Staff Report & Recommendation

Design Review Board

SUBJECT: DRB18-0354

500 Alton Road, 630 Alton Road, 650 Alton Road, 1220 6th Street, 659-737 West Avenue

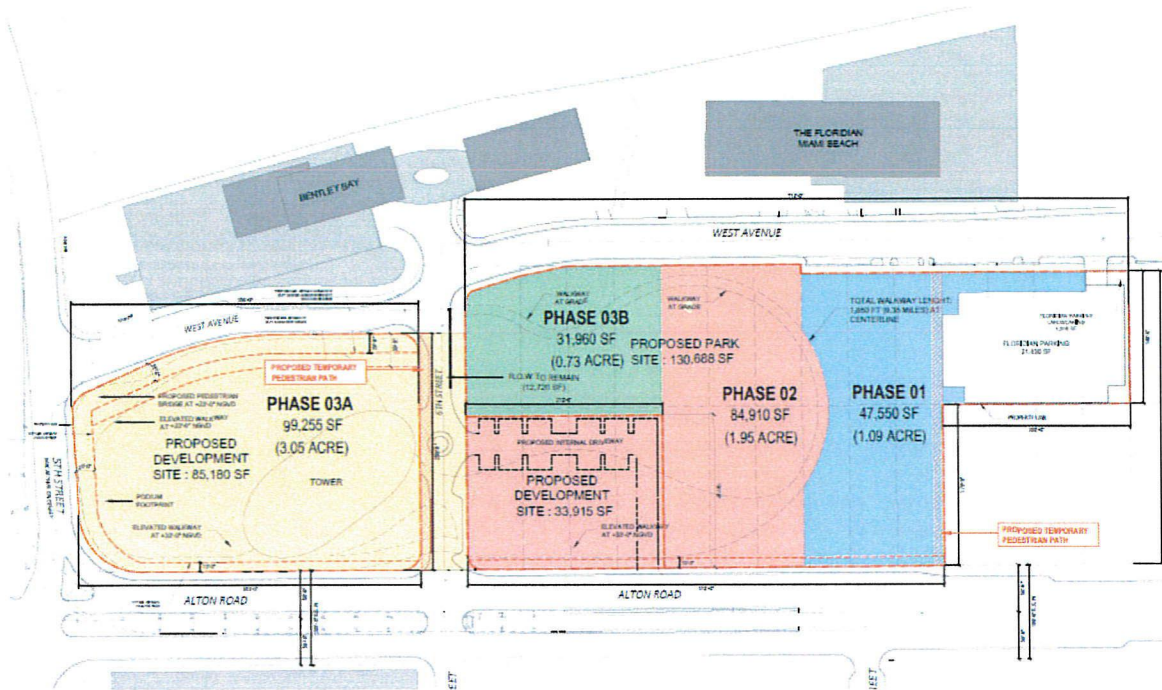
Staff believes that in a project of this magnitude, which uses a relatively simple palate of materials and finishes, the selection of the best materials and finishes, as well as meticulous attention to detail, is critical to the success of the project. Particularly, the exterior finish, color selection and materiality of the parking garage pedestal needs to be carefully studied and selected. Given that the parking podium is adjacent to the residential tower Bentley Bay, its exterior skin should be of a material that adequately and extensively screens vehicular activities along levels 0-4. Such a dynamic and monumental form is most suitable for a high quality and exciting architectural feature. It should be noted that while alluring renderings have been provided for the project, they do not, at times, reflect the reality of the ground floor interaction between the pedestrian and the garage at street level and the acknowledgement that portions of the area will be unusually heavily shaded due to the heights of the proposed tower and elevated ramping systems.
